BEFORE THE TASMAN DISTRICT COUNCIL

In the matter of Resource Consent Applications RM120928V2 (land use change of conditions), RM190790 (land use), RM190789 (subdivision), RM190791 (land disturbance), and RM191308 (water permit)

And in respect of proposed changes to the existing retirement village (Olive Estate Lifestyle Village) at Lakehouse Crescent, and a proposed extension of onto a site at Hill Street, Richmond

EVIDENCE OF GARY CLARK
Dated this 10 February 2021

Graph 1: Reported Crashes 2005 to Present day (Source: Waka Kotahi)

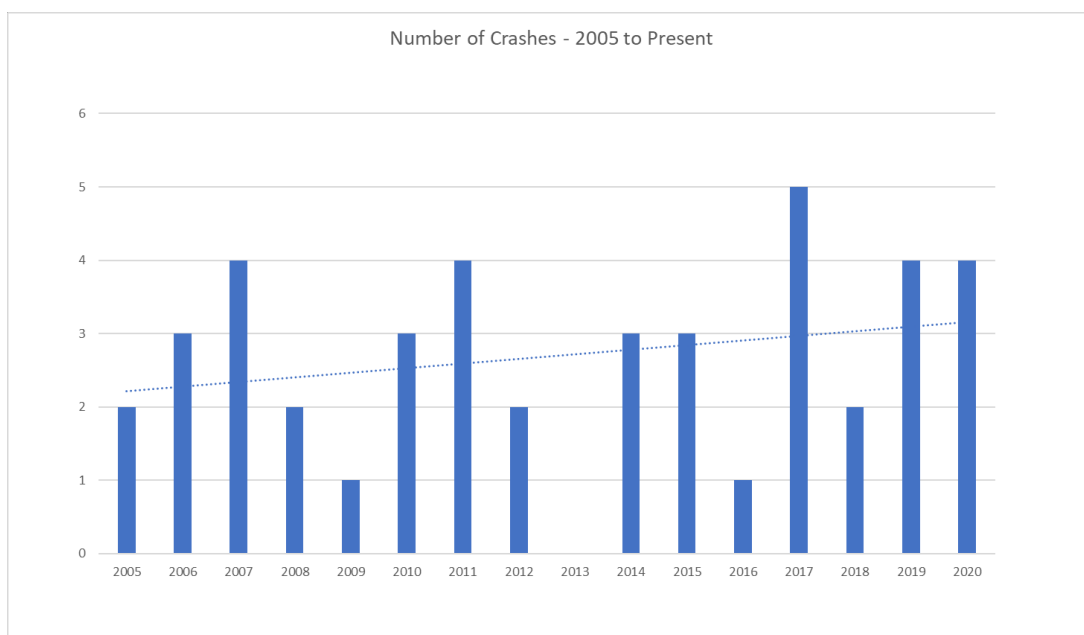
182. It is unclear why McGurk thinks 2005 is a more appropriate point in time to take crash data from. To be helpful I have carried out a brief review of crashes on the road network in the vicinity of the development from 2005 to the present date. The search area included all crashes bounded by Harte Road, Hill Street, Chelsea Avenue. The intersections of Bateup Road/Wensley Road/Harte Road, Queen Street/Hill Street, Wensley Road/Chelsea Avenue and Wensley Road/Langdale Drive were also included.

183. **Graph 1** shows the results of this crash data search.
